## POSSIBLE PX-5TD / GLOW PLUG RELAY INTERFERENCE ON A FORD 7.3 DIESEL WITH A PX-520TD

PX-5 REAR HOUSING WITH NO DIODES

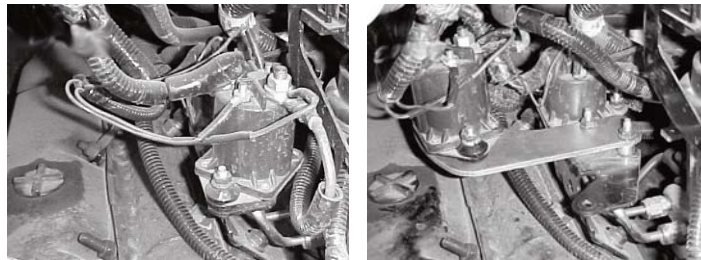
An issue has come to our attention when a PX-5T PennTex alternator is replaced with a PennTex PX-5TD-230 or 250 on a Ford 7.3 diesel. Some vehicles may have a clearance problem between the PX-5TD alternator rear case and the front glow plug relay on 2000 and up Ford 7.3 diesel engines if our relocation bracket wasn't installed.

The PX-5TD-230/250 has the negative diodes installed in the rear case making the rear case thicker than the earlier design PX-5T.

The part number for a PennTex glow plug relay relocation bracket kit is PX-5505. It is available from our Warehouse Distributors nationwide. Installation of this kit gives plenty of room behind the PX-5TD alternator.
